U.S. Forest Service – Monongahela and George Washington National Forests

Date/Time: Monday, November 21, 2016 @ 10:30am-12:30pm (Eastern)

Background

The primary purpose of the meeting was for Atlantic Coast Pipeline (ACP) to present and solicit Forest Service feedback on ACP's proposed *Best in Class (BIC) Steep Slopes Program as well as demonstrating how this would be applied to steep slopes in the National Forests*. The accompanying presentation and materials were distributed to Forest Service staff prior to or during the meeting. The notes summarize discussion and content not reflected in the accompanying materials.

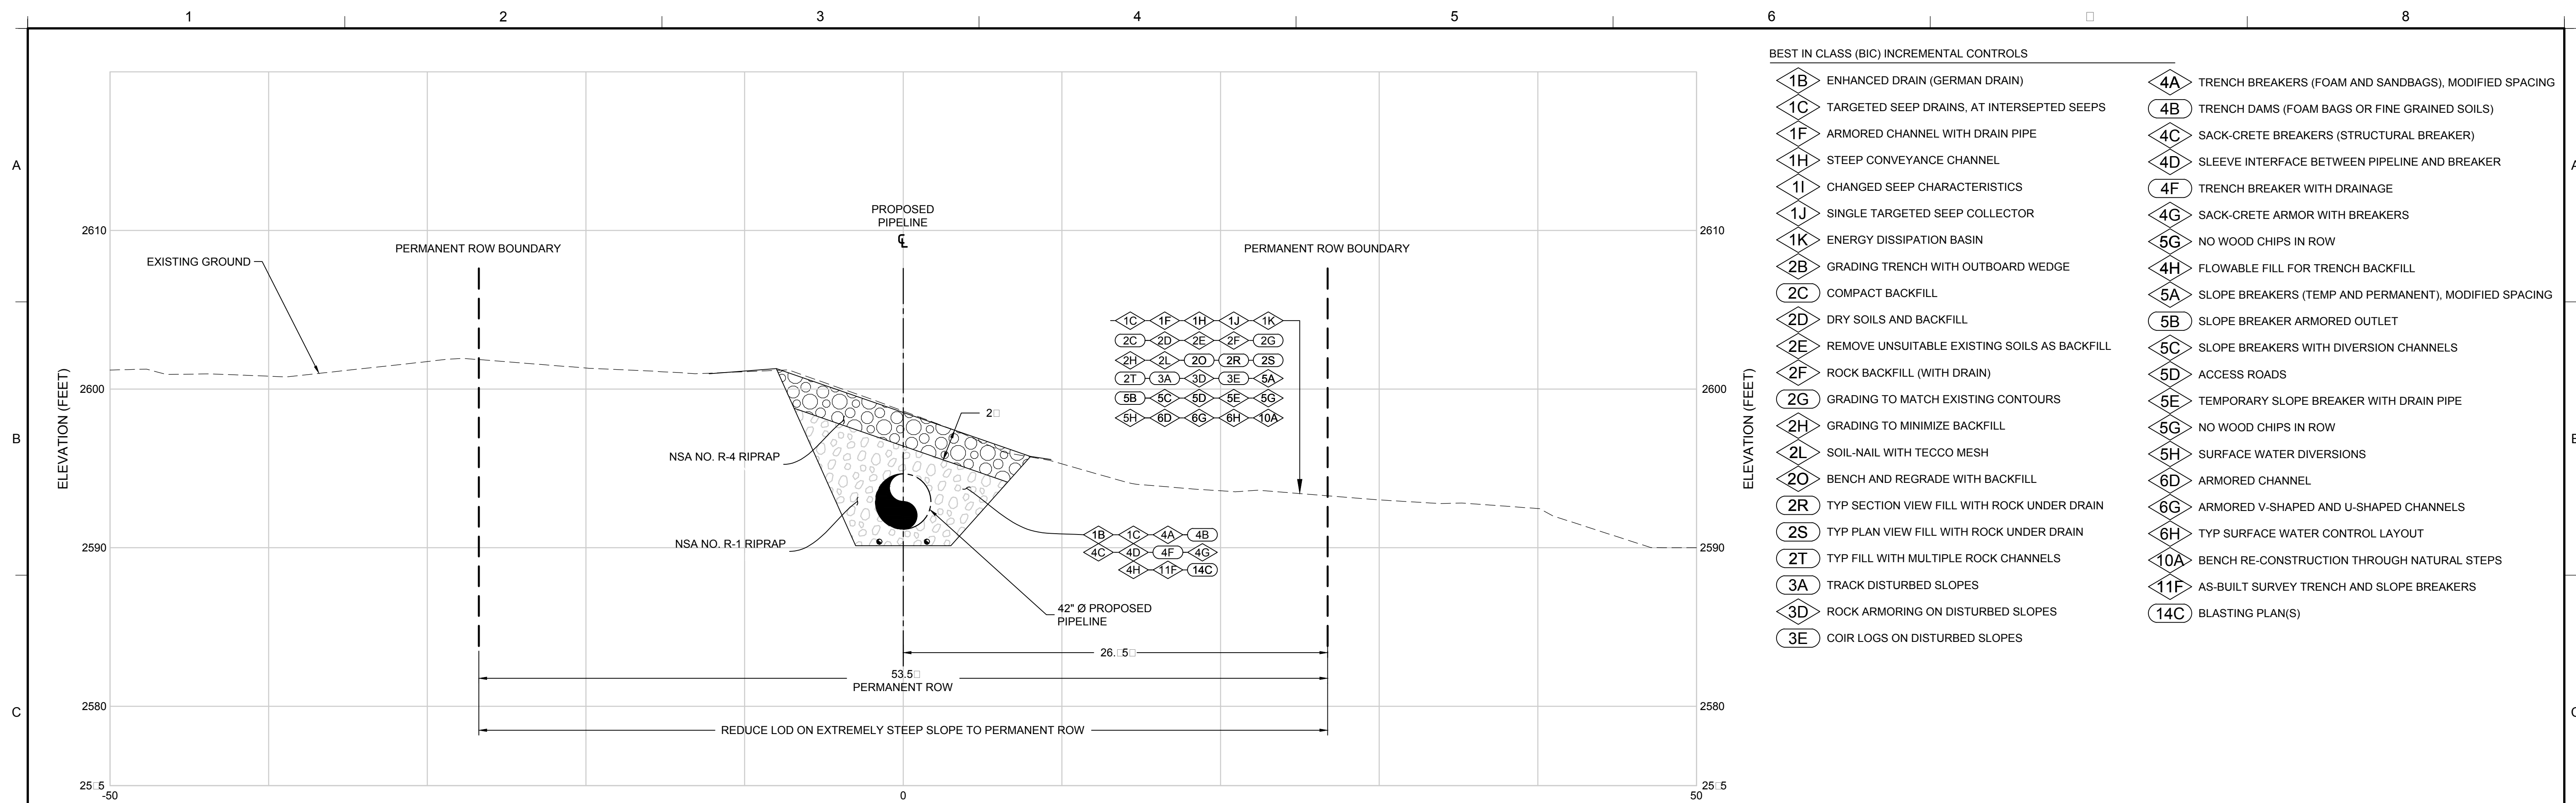
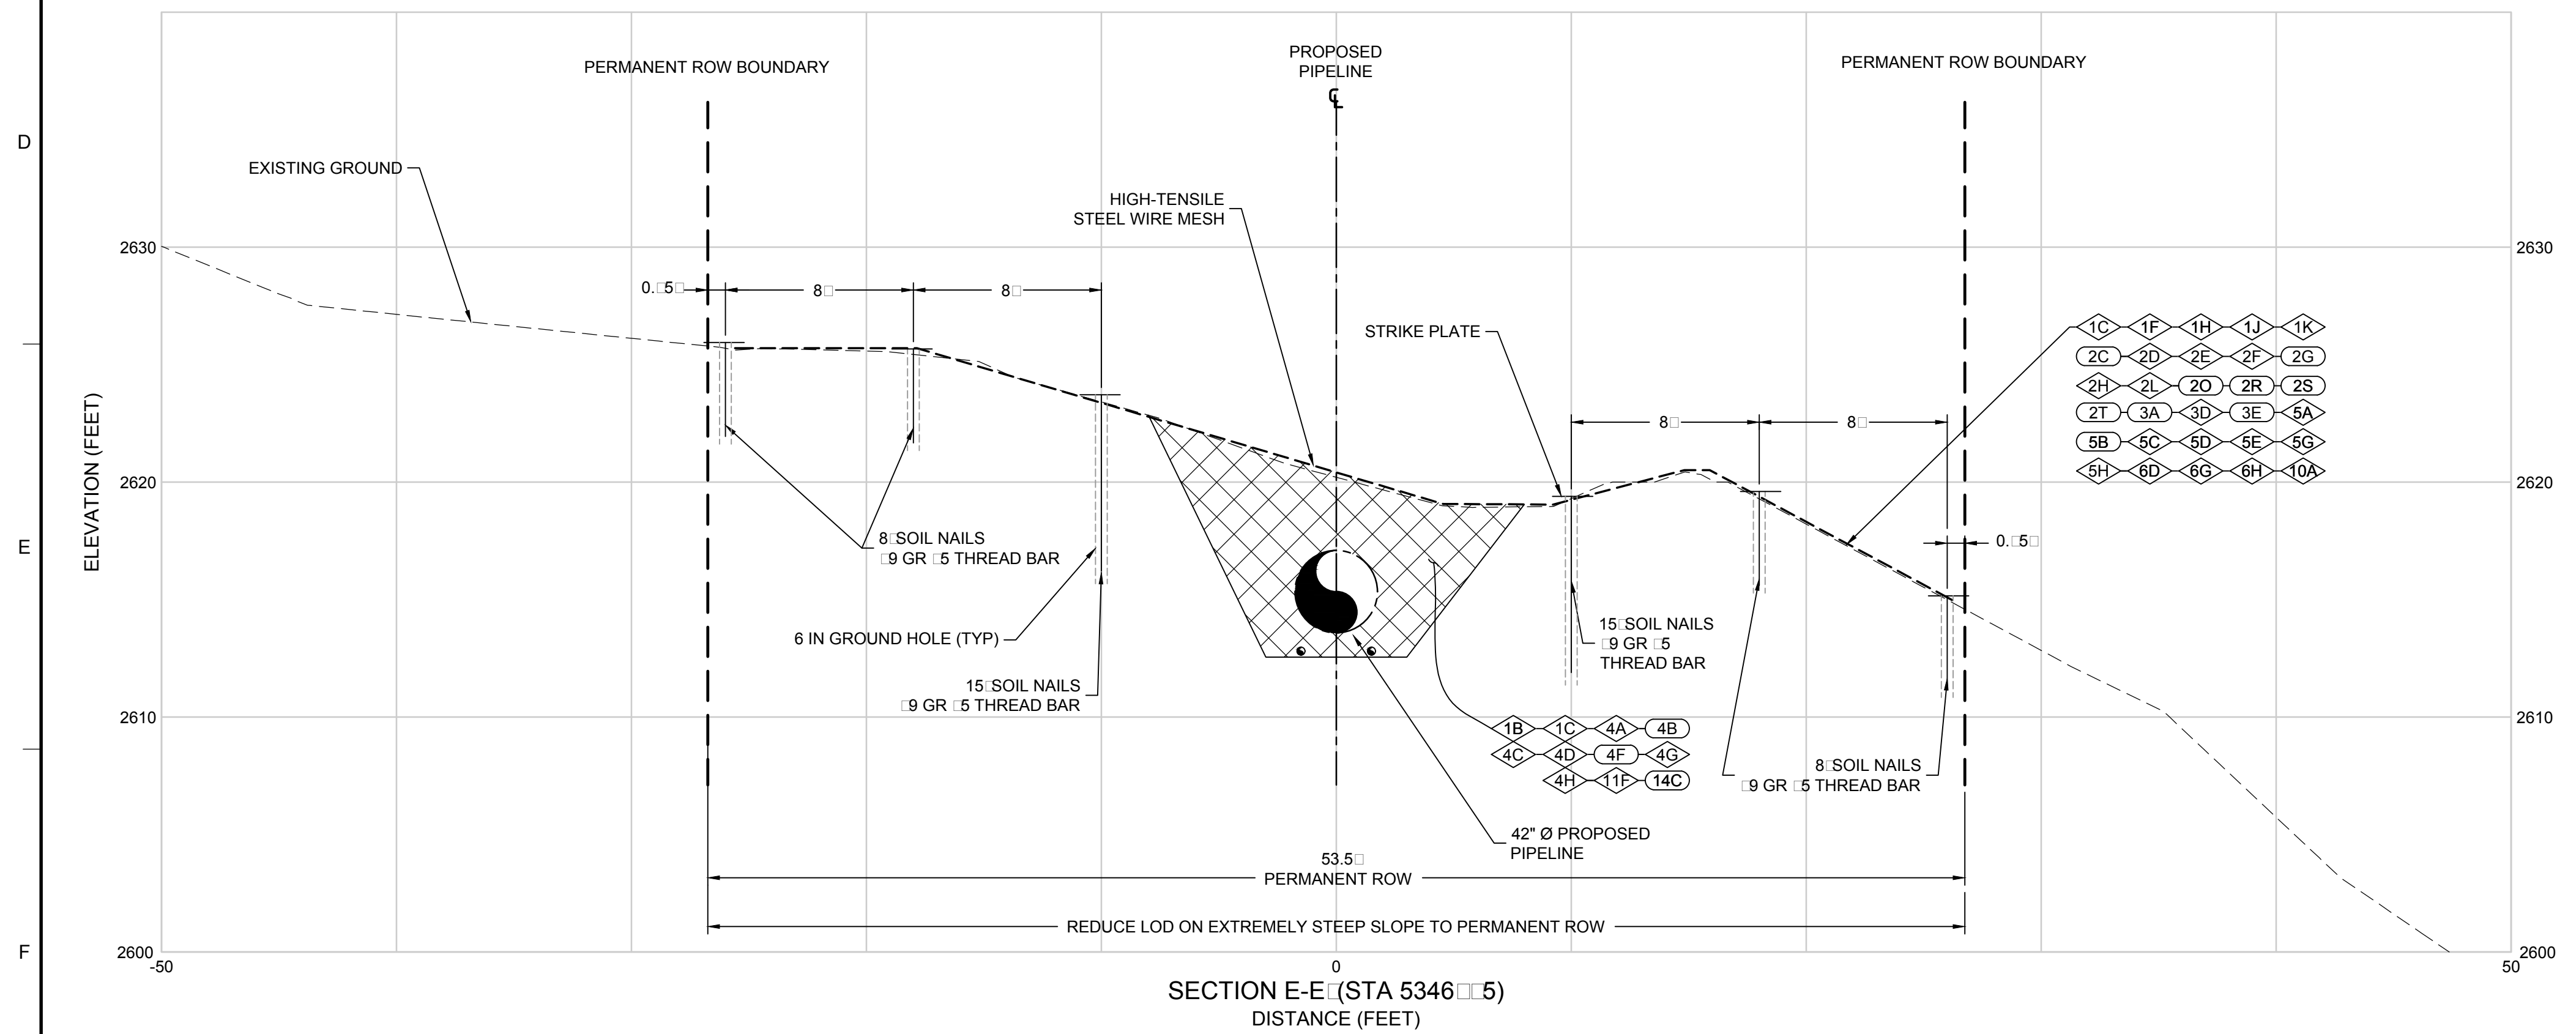
During the review of the *MP85 SECTIONS B-B' AND C-C'* slide of the *MP_85_site_specific_design_drawing.pdf*, Tom C. mentioned the slides do not show profiles for restoration. He also noted the slides show spoils piles at slope ratios greater than one to one. Tony said the drawings are not intended for engineering. Tom C. replied that the Forest Service wanted to see details of how the loose, excavated materials would be managed during and after construction, and, for example, how high and at what angle spoils will be piled. Tom C. said the design needs to consider the swell factor (bulking factor) particularly for excavated bedrock, and the design drawings need to reflect swell factors as well as realistic angles for spoil piles and other temporary storage of loose, excavated materials. Tom C. said the drawings are a step in the right direction but more detail is needed for site specific design, the Forest Service needs to see how this lays out on the land. Clyde acknowledged the Forest Service would likely have many detailed questions and proposed that further meetings be scheduled.

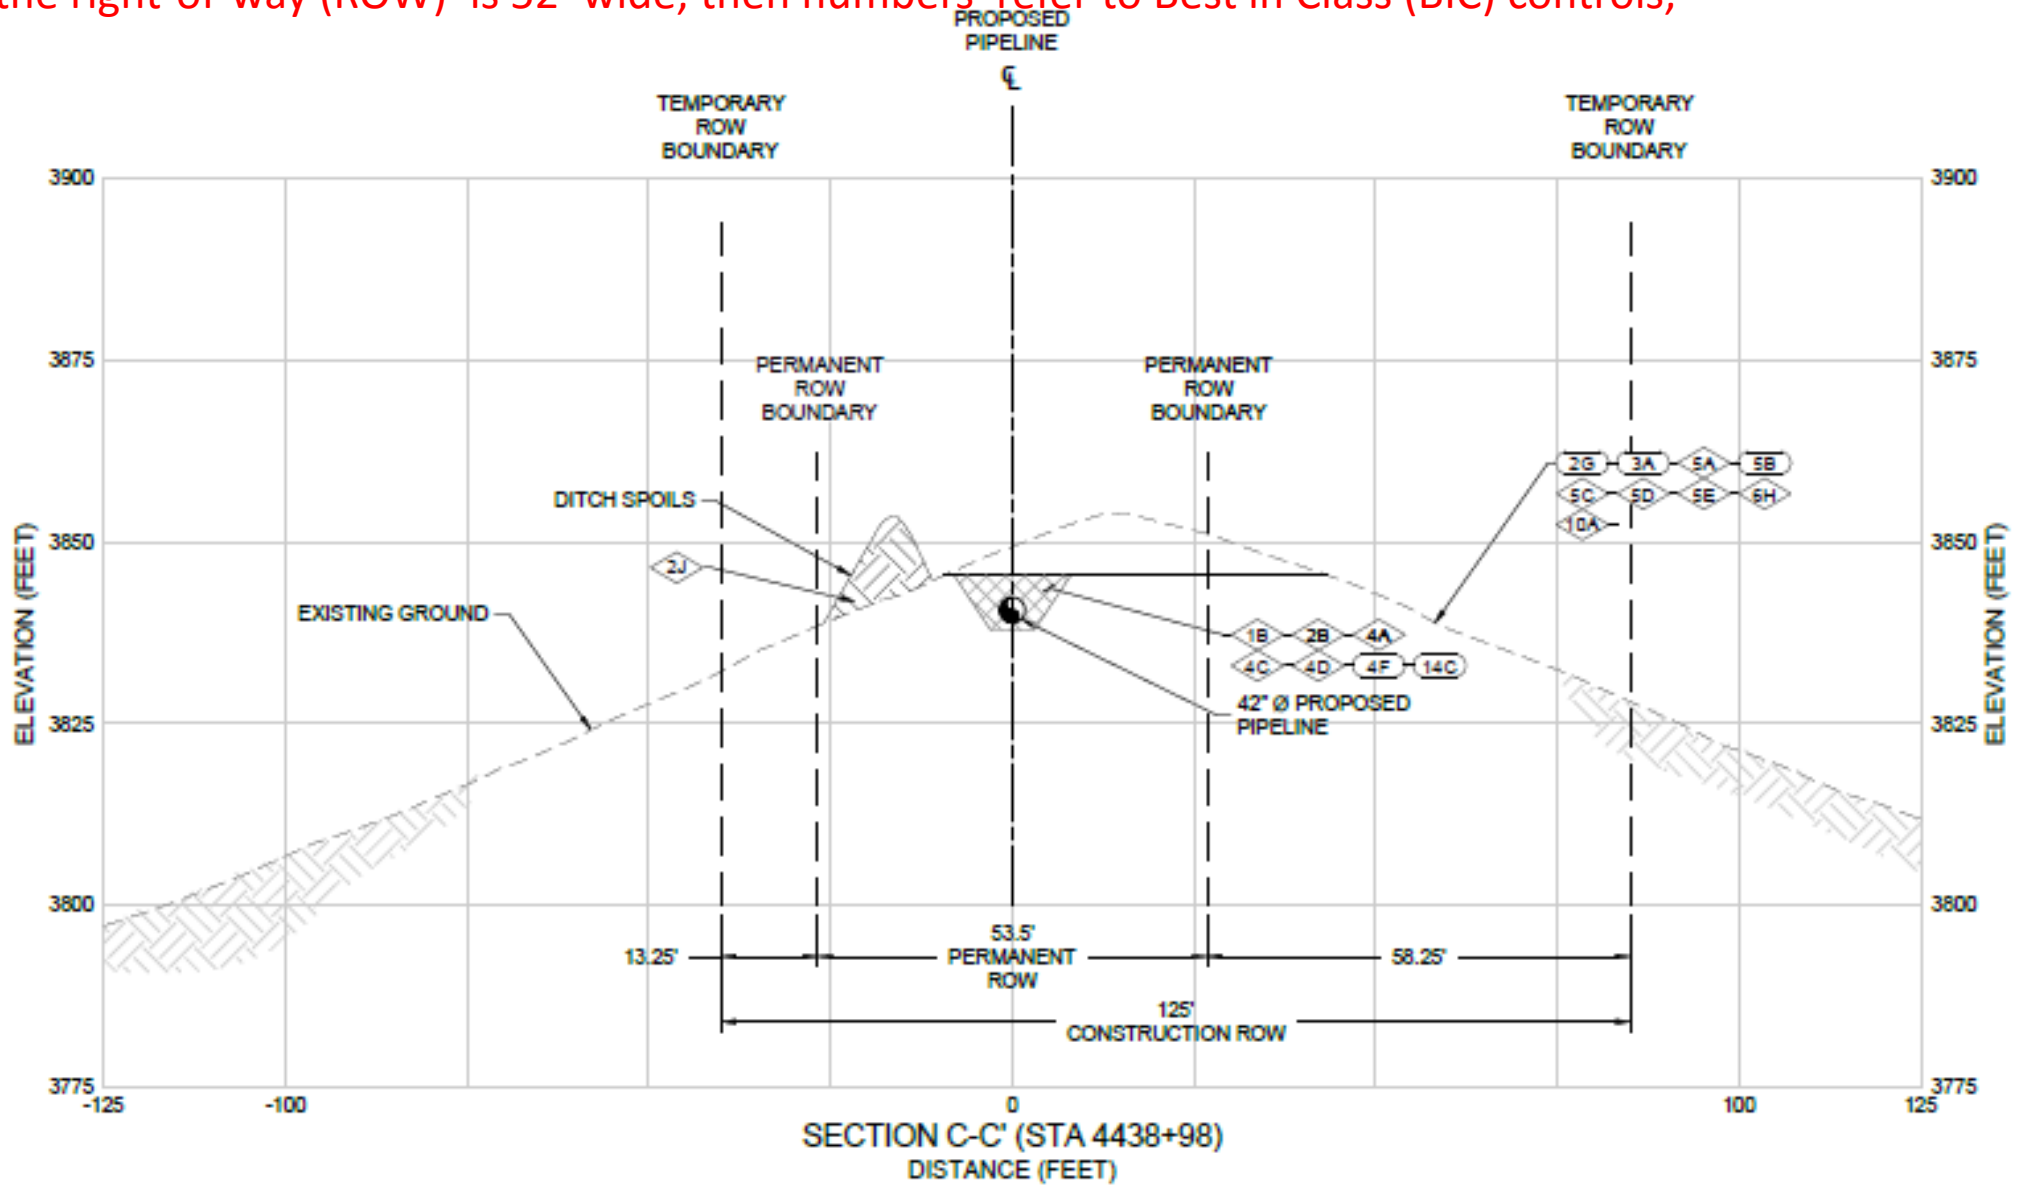
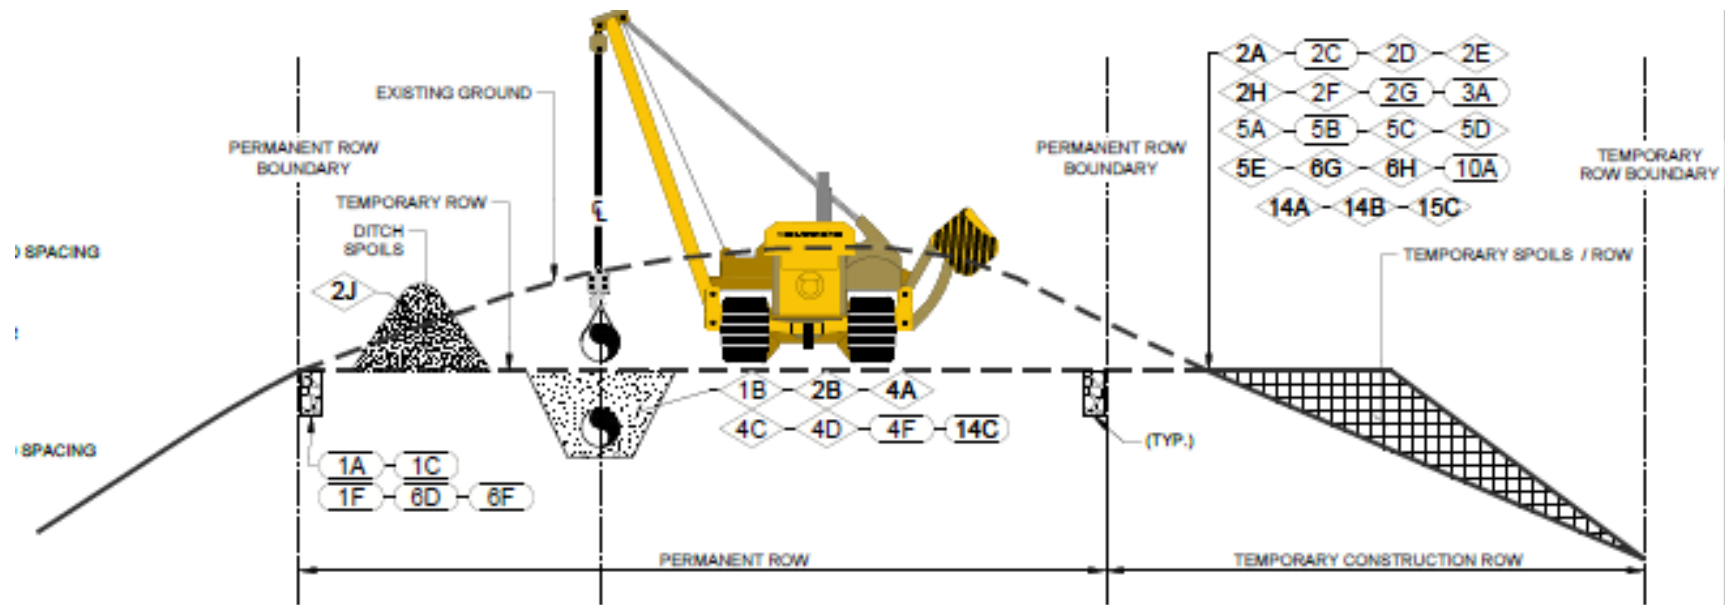
Tom C. the right-of-way (ROW) is 52' wide, then numbers refer to Best in Class (BIC) controls,
